Your Ref
APP/15/00303
Our Ref
PLAN-009445
Date
10/04/2015

Proposal: Havant Health and Well-Being Campus, comprising an 80-bed nursing home, 51 affordable extra care flats, 48 affordable and market supported living flats, community hub facilities, car parking, with vehicular access from River Way..

Site: Former Oak Park School, Leigh Road, Havant, PO9 2EL.
APP/15/00303

O.S. REF: SU7207SW

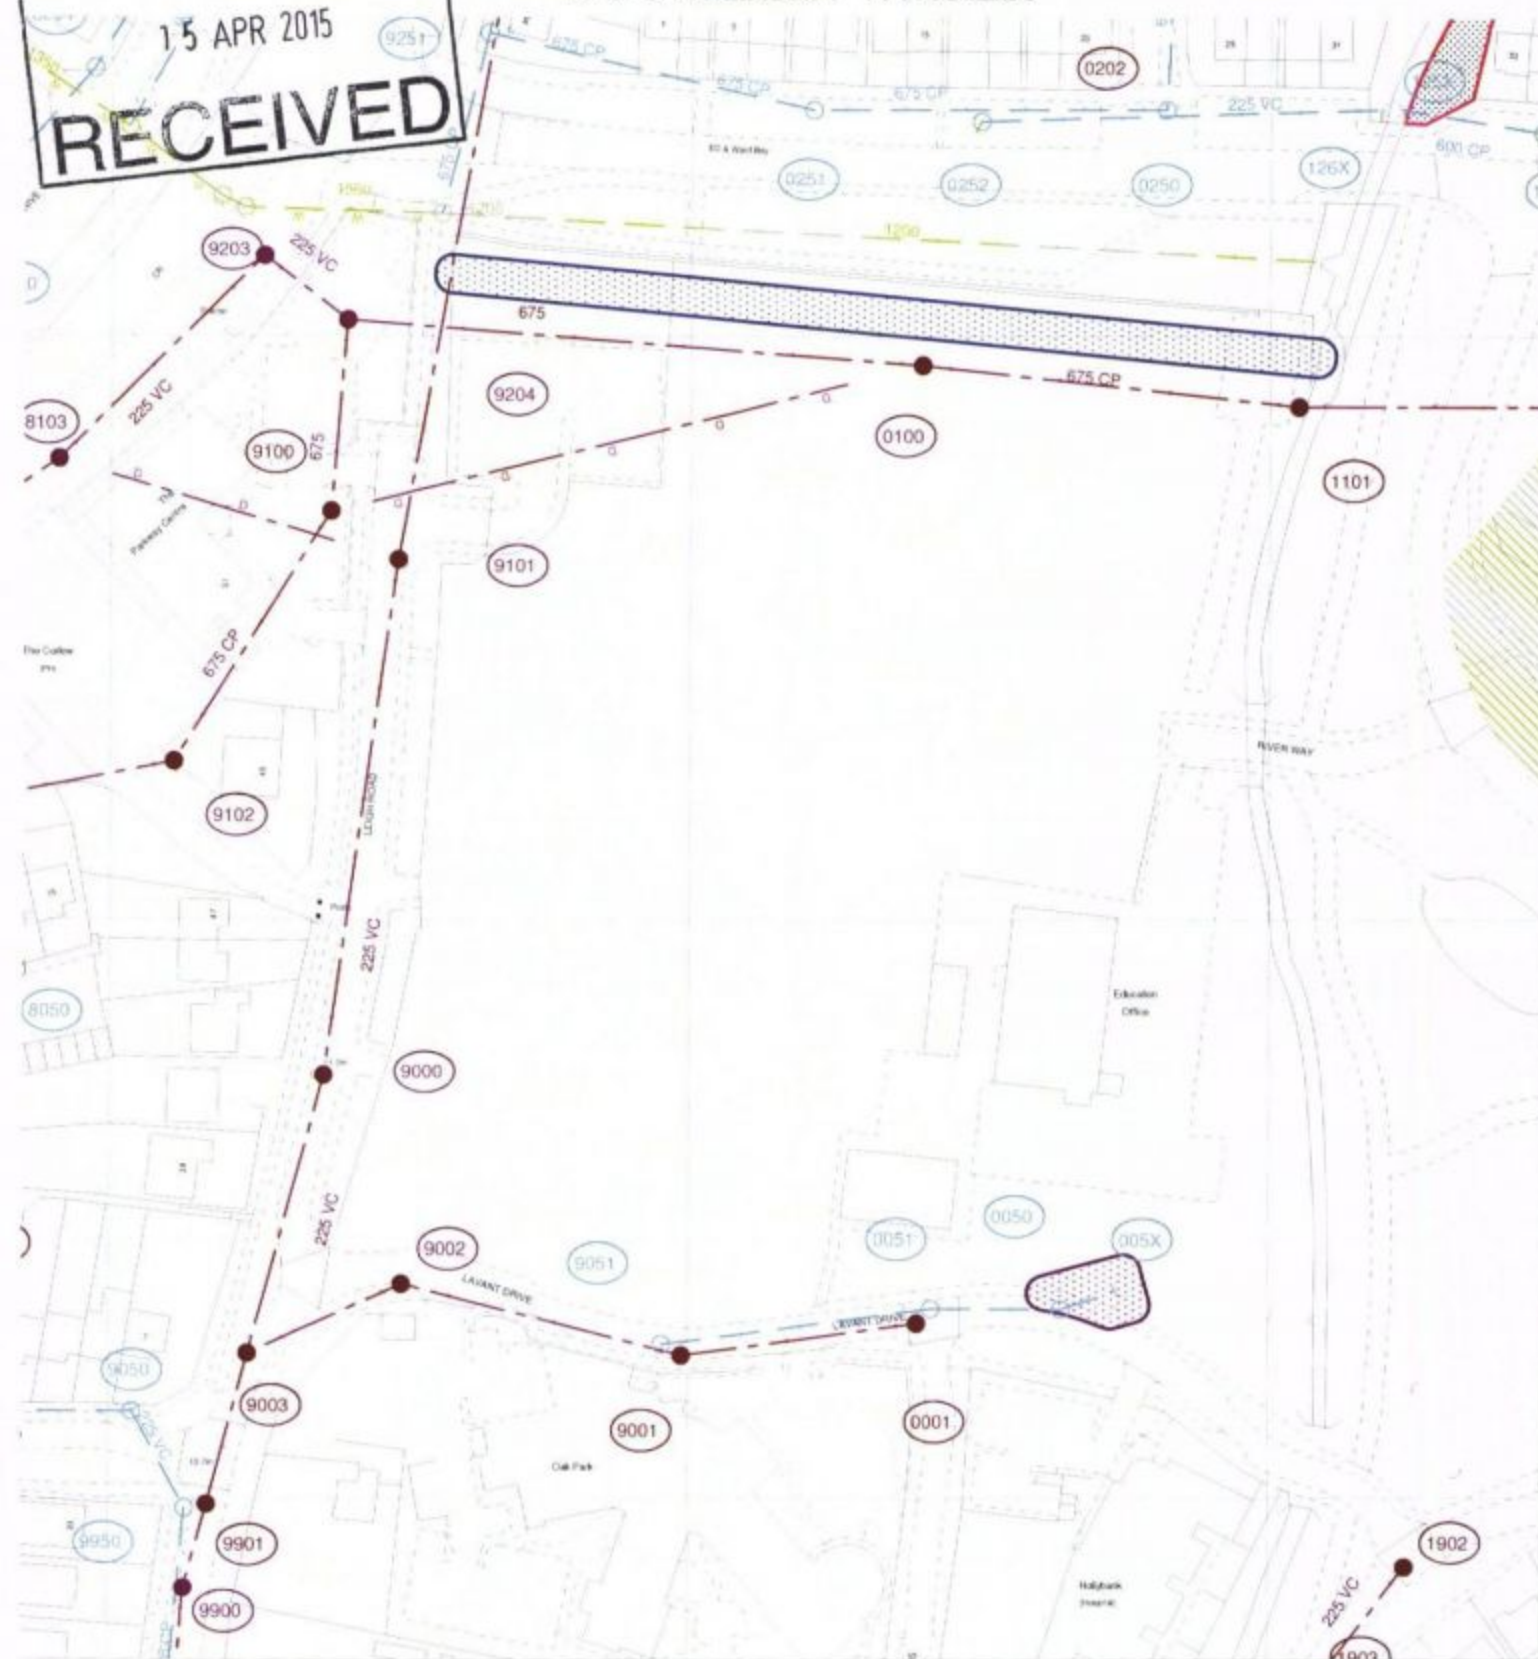
Please find attached a plan of the sewer records showing the approximate position of a public foul sewer crossing the site. The exact position of the public sewers must be determined on site by the applicant before the layout of the proposed development is finalised.

- No development or new tree planting should be located within 3.5 metres either side of the centreline of the public sewer and all existing infrastructure should be protected during the course of construction works.
- No new soakaways should be located within 5 metres of a public sewer.

Please note there is deed of easement for sewer and a decommissioned sewer within the site.
